MONITORING YEAR 1 ANNUAL REPORT

KEY MILL MITIGATION SITE

RE: Draft MY1 Report Review
Key Mill Mitigation Site, Surry County
Yadkin River Basin – HUC 03040101
DMS Project ID No. 100025 / DEQ Contract #7180

Wildlands Engineering, Inc. (Wildlands) has reviewed the Division of Mitigation Services (DMS) comments from the Draft MY1 Monitoring report for the Key Mill Mitigation Site. The report has been updated to reflect those comments. The Final As-built Baseline Monitoring Document and Record Drawings are included. Wildlands' responses to DMS' report comments are noted below in *italics*.

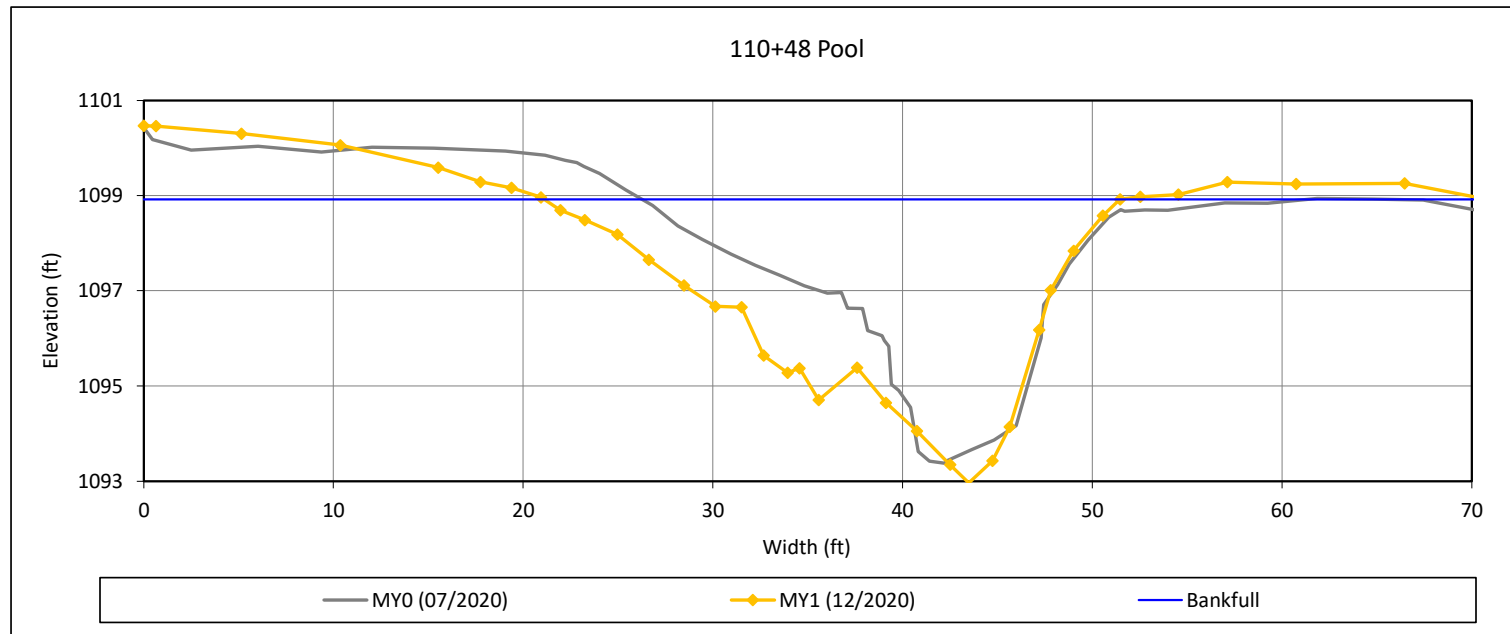
*Repairs were conducted on the left bank of XS3 during MY1 prior to the collection of the MY1 cross-section data and photos. The MY1 plot line shows the repaired cross-sectional profile. Also the station number for XS3 was incorrectly reported on the MY0 cross-section plot, it should have been reported as Station 110+48 as shown in the above plot.
